APPROVING AMENDMENT TO THE CONCEPTUAL DEVELOPMENT
PLAN FOR THE SOUTHRIDGE MALL TO AMEND THE DESIGN OF THE
PROPOSED UNITY POINT MEDICAL CLINIC AT 6520 SE 14th STREET

**Amended Conceptual Development Plan
for the Unity Point Clinic at 6520 SE 14th Street**
an amendment to the Conceptual Development Plan
for the overall Southridge Mall project area

UNITY POINT SOUTHGLEN
 6520 SE 14TH STREET
 DES MOINES, IOWA
 09-12-2017

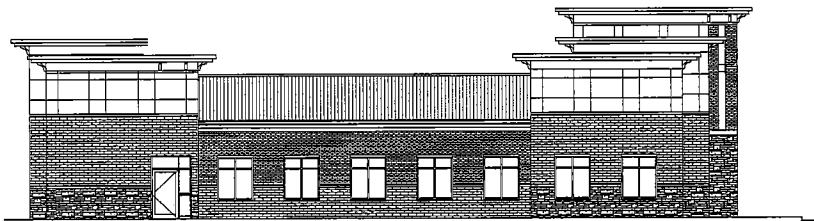
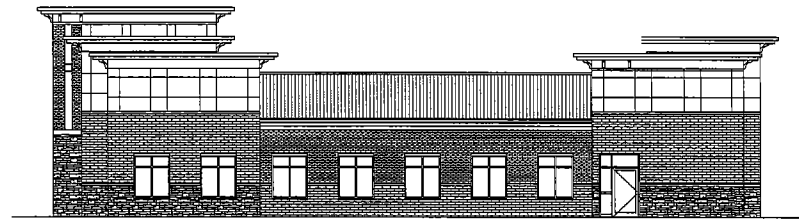
WHEREAS, on September 26, 2017, the Urban Design Review Board reviewed the Amended Conceptual Development Plan for the medical clinic, and by consensus the seven members present expressed their support for the amended Plan, subject to further amendment of the Plan to address the following concerns:

- Take a look and provide more detail of the transitions between building materials, particularly between the brick and the EIFS material on the tower features above the roof line.
- Bring down the "proportionality" of the upper floor elements. The building is trying to appear as 2 stories, but the elements are decorative only.
- Study if window glazing could be added to the upper floor elements in lieu of solid materials.
- Try reducing the slope of the main portion of the roof, which could cause the upper floor elements to be reduced in height and stature.

MOVED by _____ to adopt, subject to the Amended Conceptual Development Plan being first amended to address the concerns raised by the Urban Design Review Board, and to the Economic Development Director approving the amended Plan as having adequately addressed the Board's concerns.
